14/59-07A Master Plan Site #14/59  
(Fertile Meadows)  
9000 Brink Road, Gaithersburg

SUBJECT: Historic Area Work Permit #464716, rear addition, patio reconstruction and tree removal

**MONTGOMERY COUNTY HISTORIC PRESERVATION COMMISSION**  
**STAFF REPORT**

**PROPOSAL:** Rear addition, patio reconstruction and tree removal

REAR ELEVATION

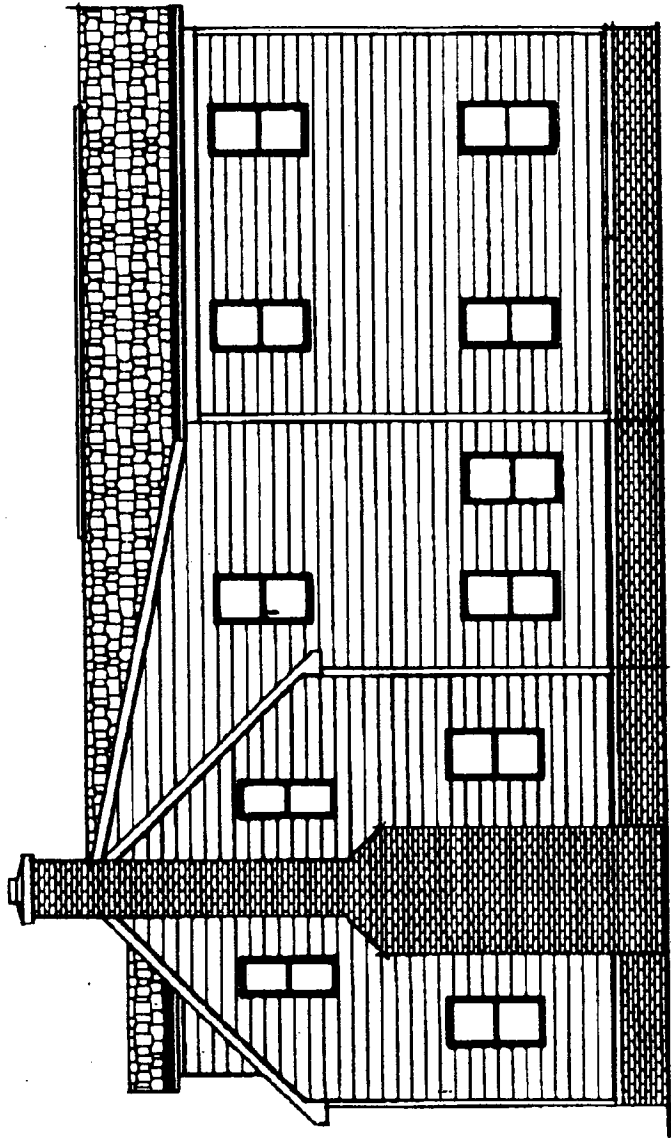
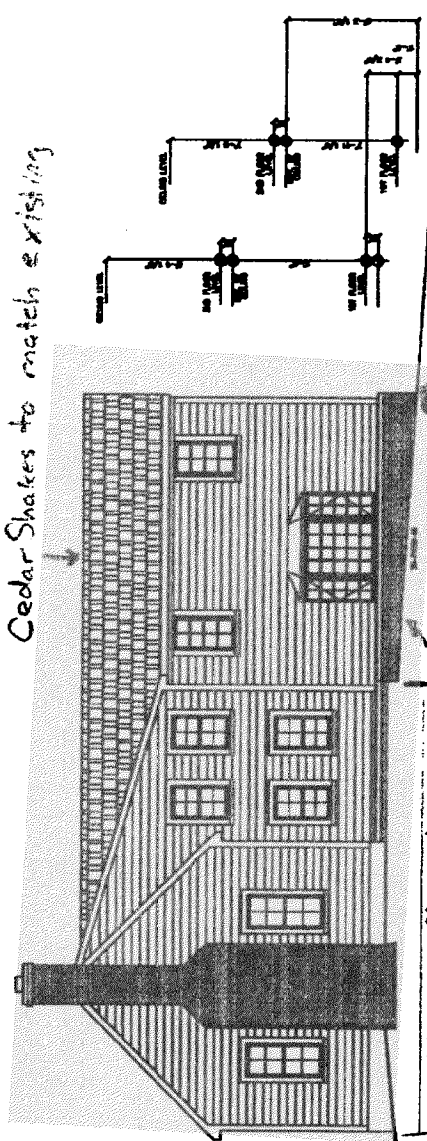
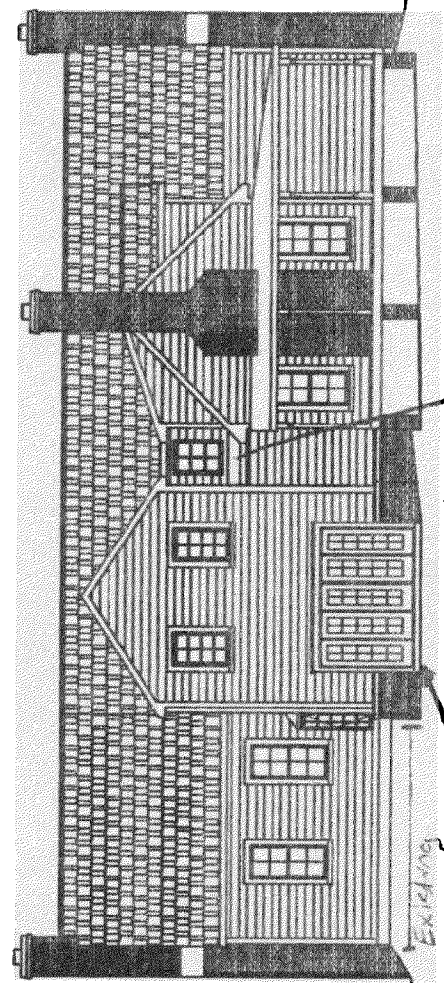
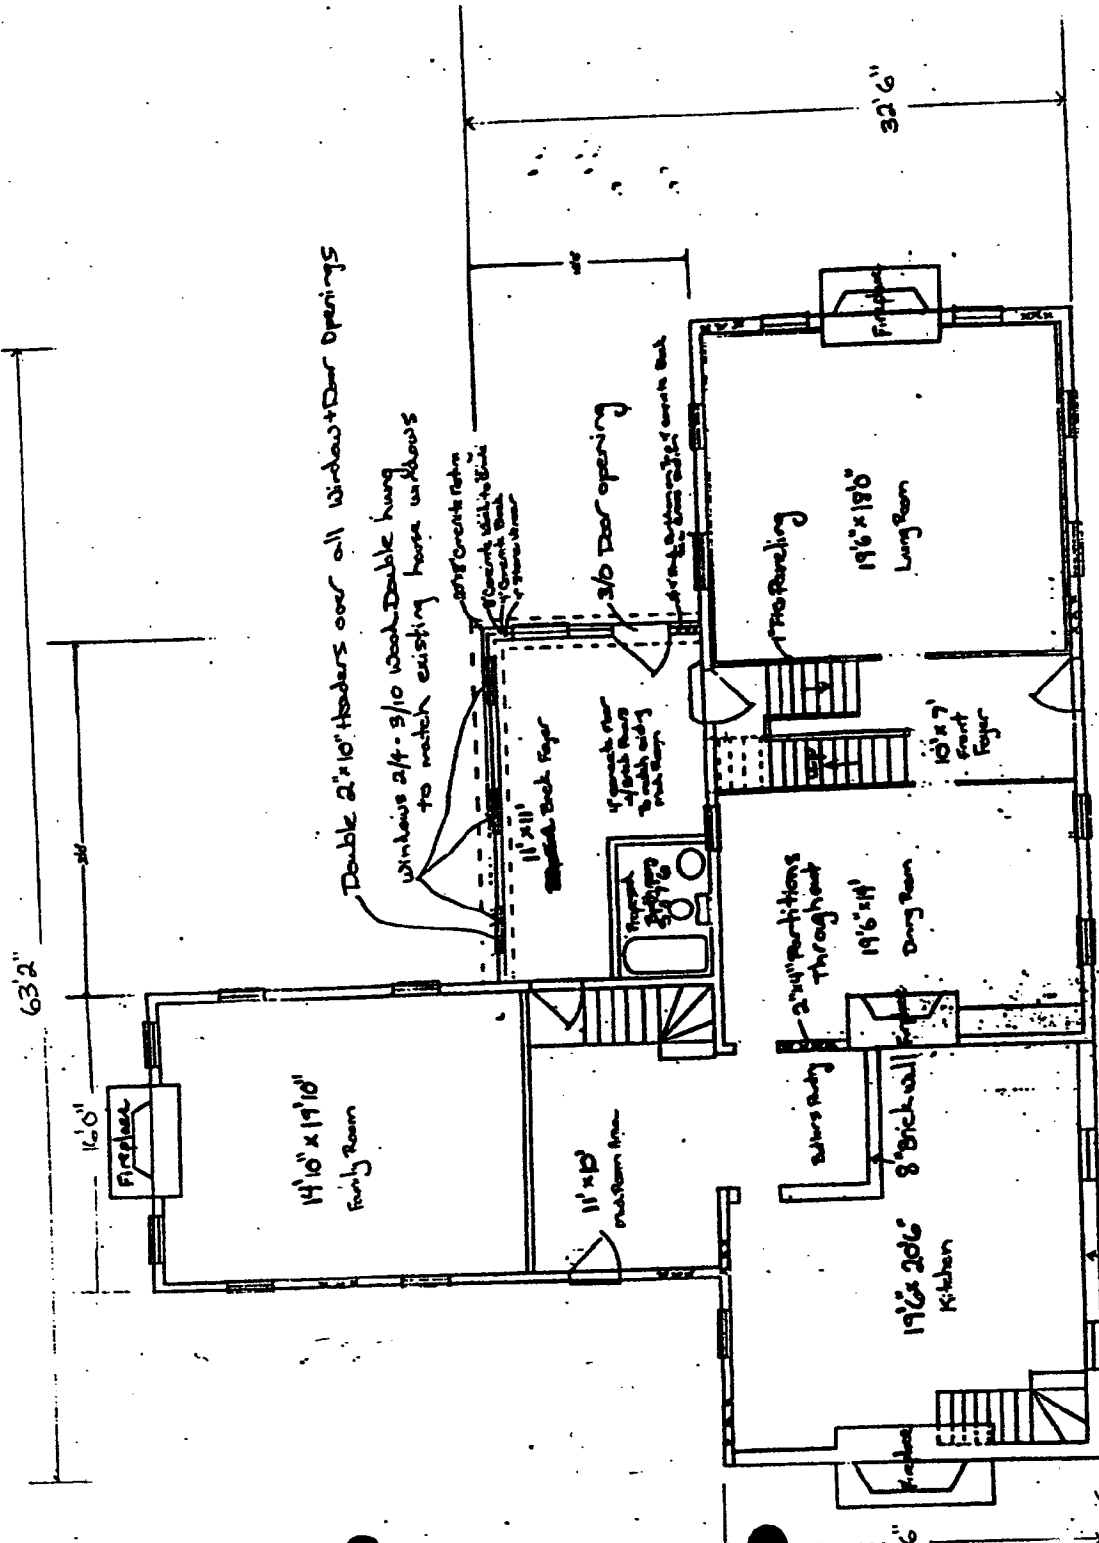
While the current proposal contains many similar design elements to the approved 2004 HAWP Pages 11 and 12, several modifications have been proposed to the two-story rear addition. These include:

- Conversion of two windows on the first floor into two, double wooden French doors.
- Removal of a French door from the hyphen.
- Increase to the overall length of the addition's footprint by 3'.
- Elimination of two windows on the first floor of the right elevation and installation of a bay window.
- Installation of an additional window on the second floor of the shed roof portion of the new addition, to balance the elevation.

The proposed addition successfully addresses the Commission's concerns about the previous HAWP submittal with regard to the lowering of the addition's ridgeline, however the current proposal increases the footprint of the addition's length by 3'. Given the location of the addition at the rear of the house the proposed plan will not negatively affect the remaining historic fabric on the c1850s addition. The existing brick patio adjacent to the house will be removed and relocated to the rear of the proposed two-story addition. The proposed plan for the addition and relocated brick patio are very sympathetic to the existing historic resource, as such staff recommends approval.

Staff recommends that the Commission **approve** the HAWP application **with the condition specified on Page 1** as being consistent with Chapter 24A-8(b)(1) & (2);

## **ATTACHMENT 5: Tree Survey**

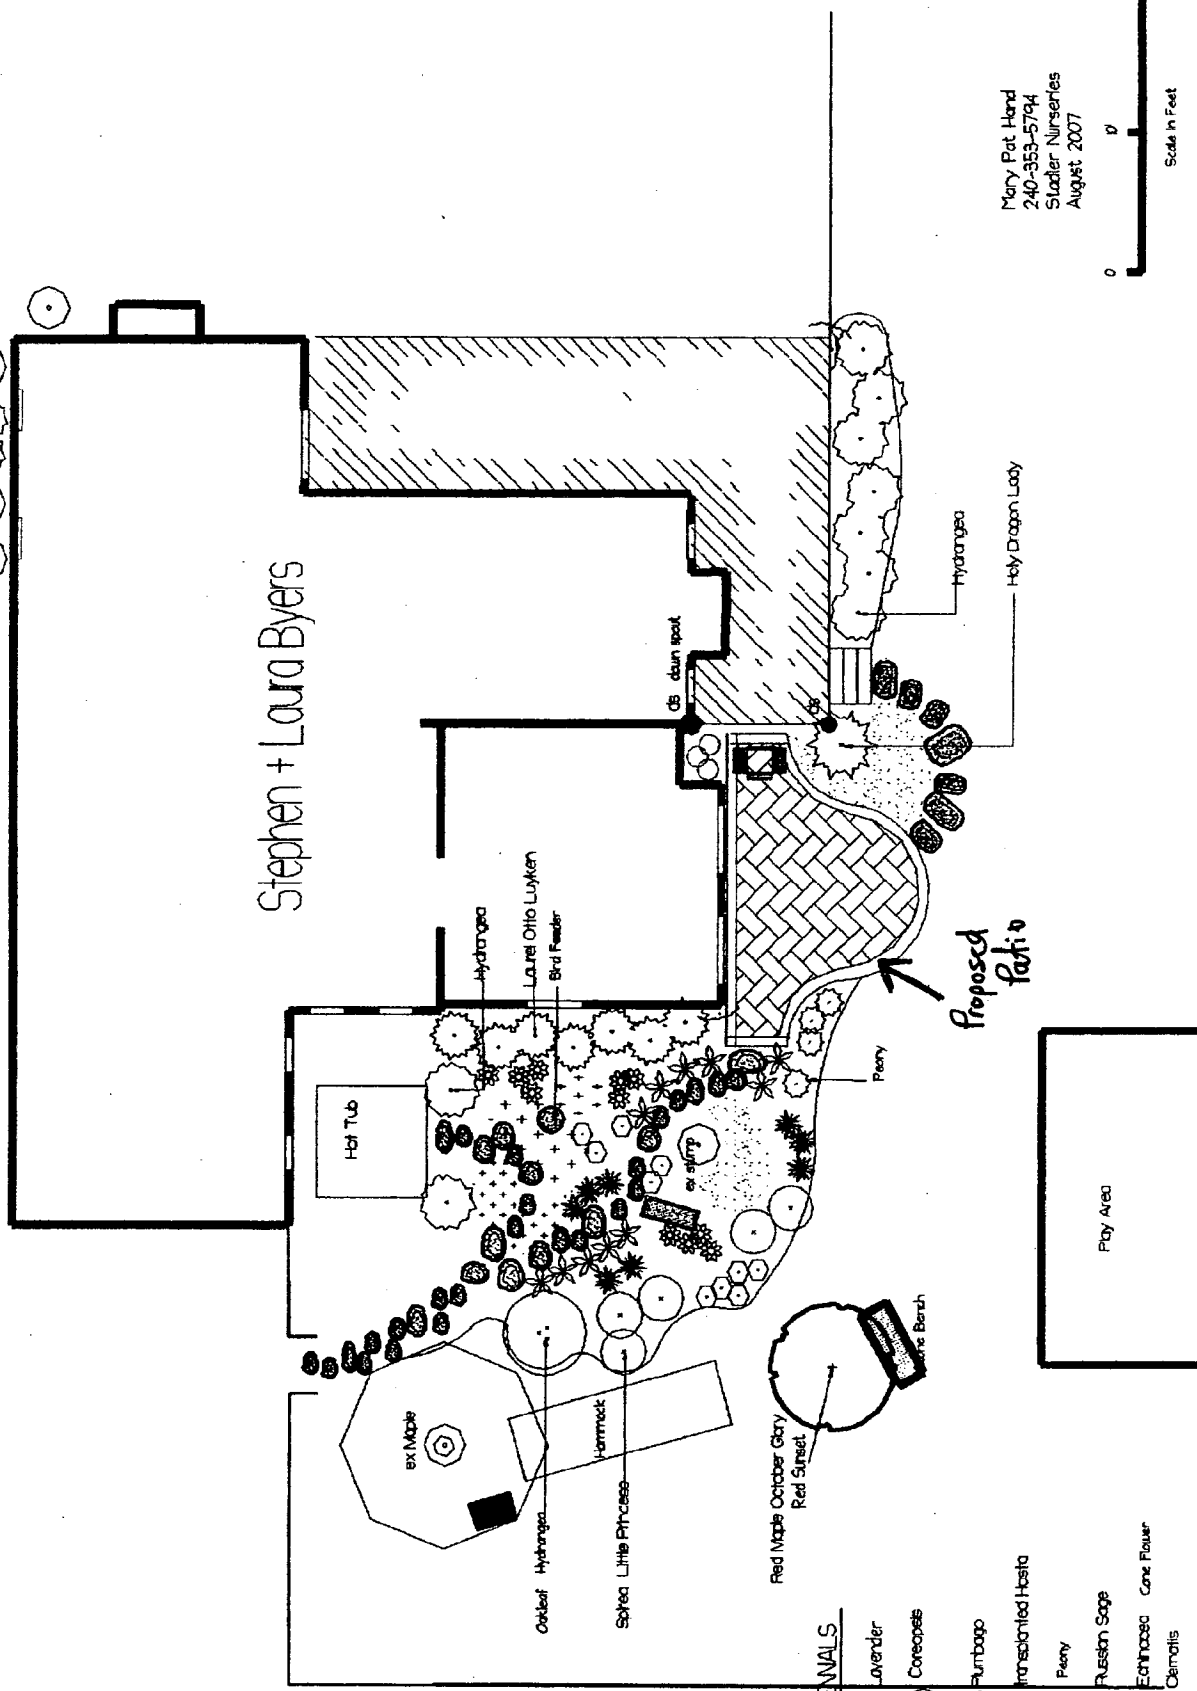
While the tree removal was approved by the Commission in 2004, staff is encouraged by the applicant's proposal to plant one mature tree to mitigate the loss of the large Maple. Staff additionally notes that this property contains several mature trees – and as such the removal of this tree will not have a negative affect on the existing landscape. Staff recommends approval.

REAR ELEVATION

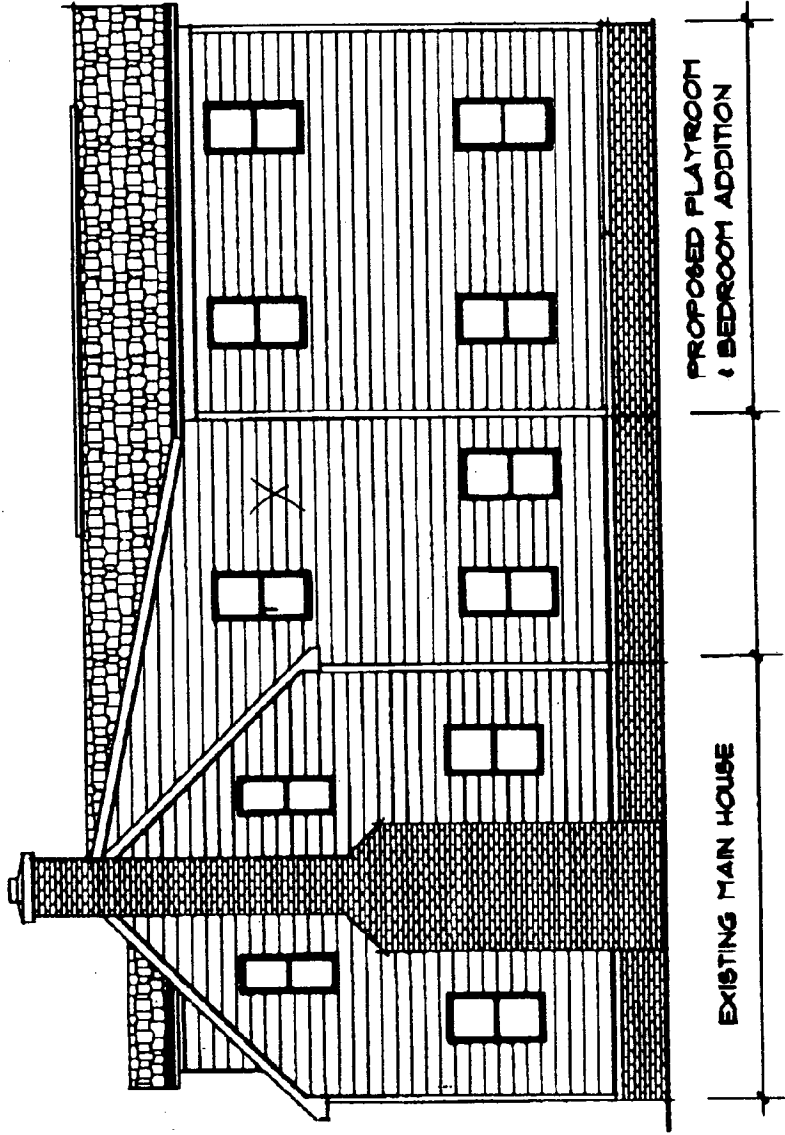
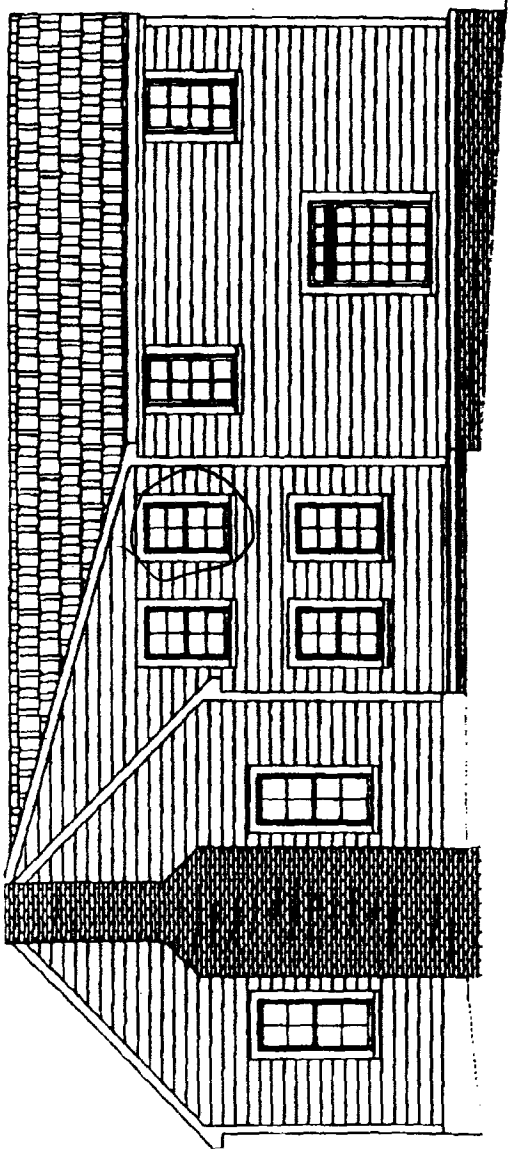
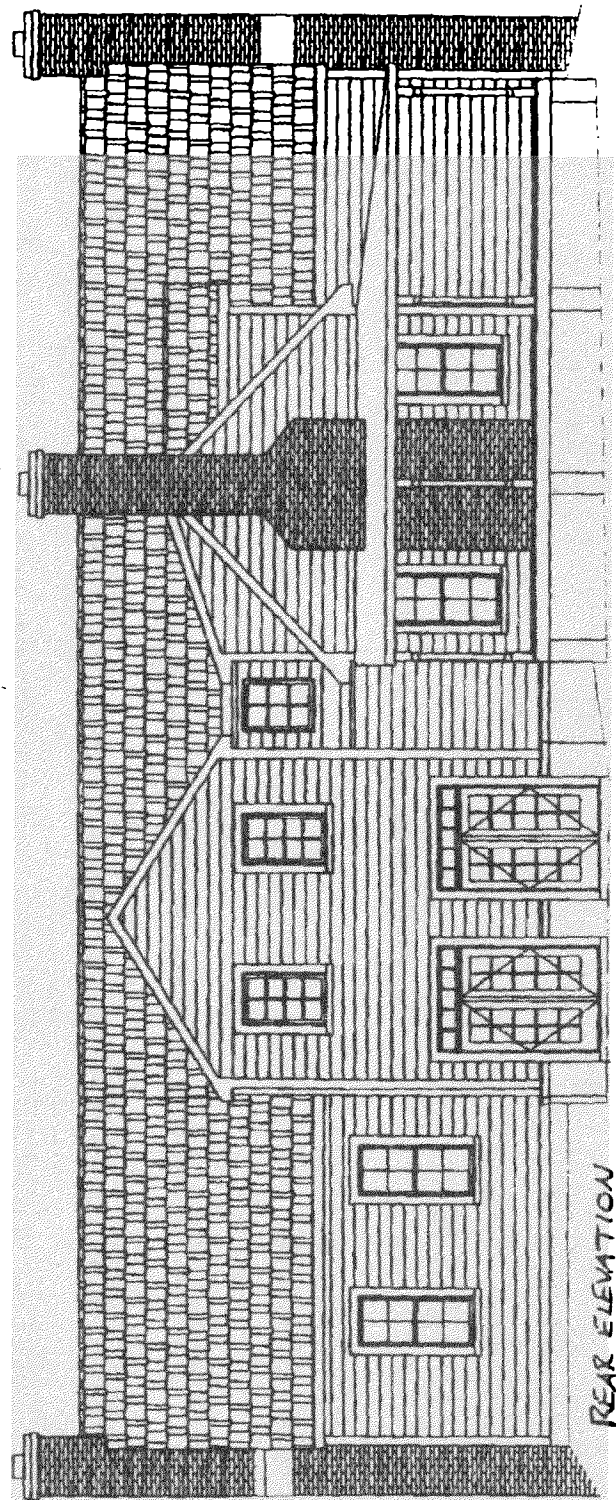
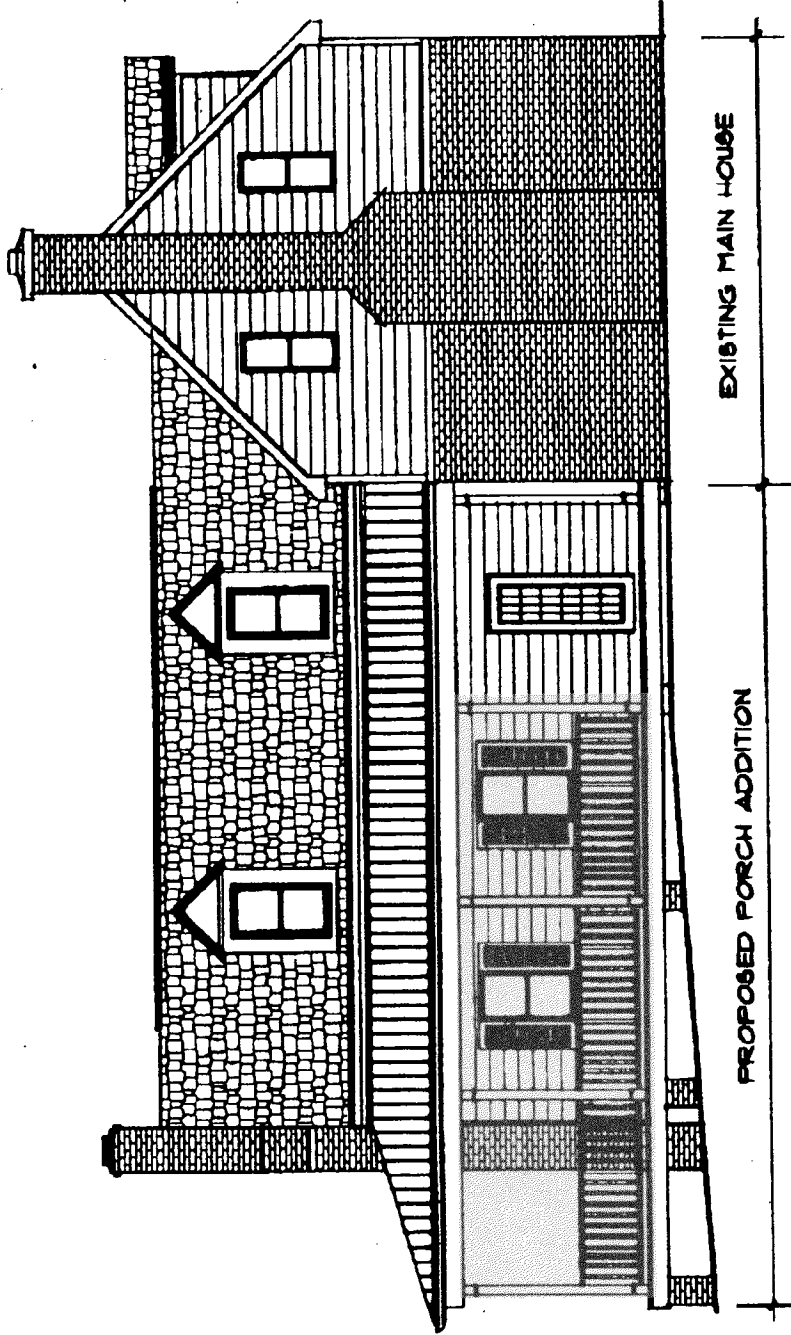
- Converting two, windows on the first floor of the approved two-story addition into two, double French doors with transoms.
- Remove a French door from the hyphen.
- Increase the overall length of the addition's footprint by 3'.
- Eliminate the two, windows on the first floor of the right elevation and replace them with a single, fixed sash, 20-light window with transom.
- Install an additional window on the second floor of the shed roof portion of the new addition, to balance this elevation.

- Removal of the transoms on the proposed French doors and 20-light window.
- The raising of the 20-light window to the height of the not-approved transom.

To many changes  
→ Site plan etc,  
HPC for public review  
Fall HAWP review

Significant changes come back or  
build what is approved.

STAFF ITEM  
PRESENTED TO HPC  
THEY REQUESTED  
THE APP RETURN FOR  
HAWP  
See approved HAWP
